AMENDMENTS TO THE DRAWINGS

REMARKS

FIG. 4

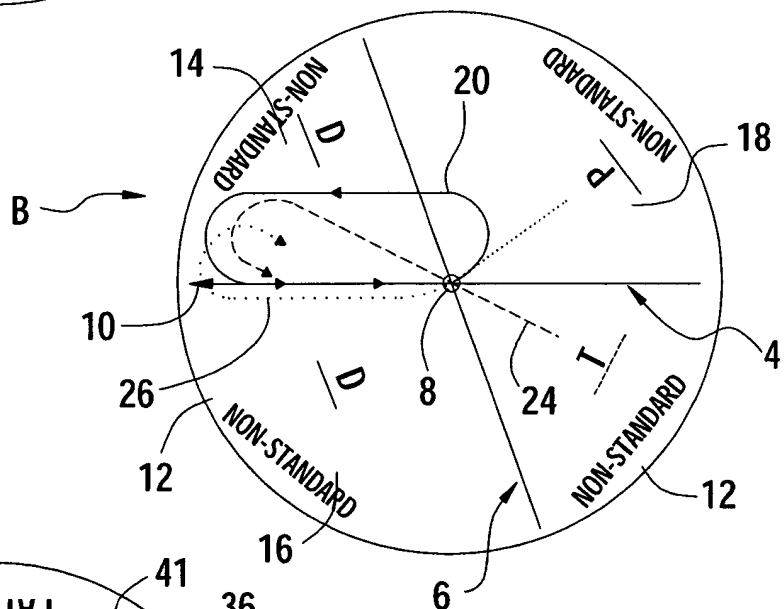
The attached sheet of drawings includes changes to FIG. 4. The sheet, which includes FIGS. 2-4 replaces the original sheet including FIGS. 2-4 and is labeled "Replacement Sheet". In amended FIG. 4, the designator lines 41 and 43 have been modified to point to the arrows in patterns 40 and 42, respectively, as indicated in the specification. No other changes to FIG. 4 (or any of the other drawings on the Replacement Sheet) have been made.

The Applicants have requested that FIG. 4 be amended to more precisely point out the elements indicated by designators 41 and 43. A copy of the proposed Replacement Sheet and annotated sheet showing the requested amendments is attached in the Appendix to this response
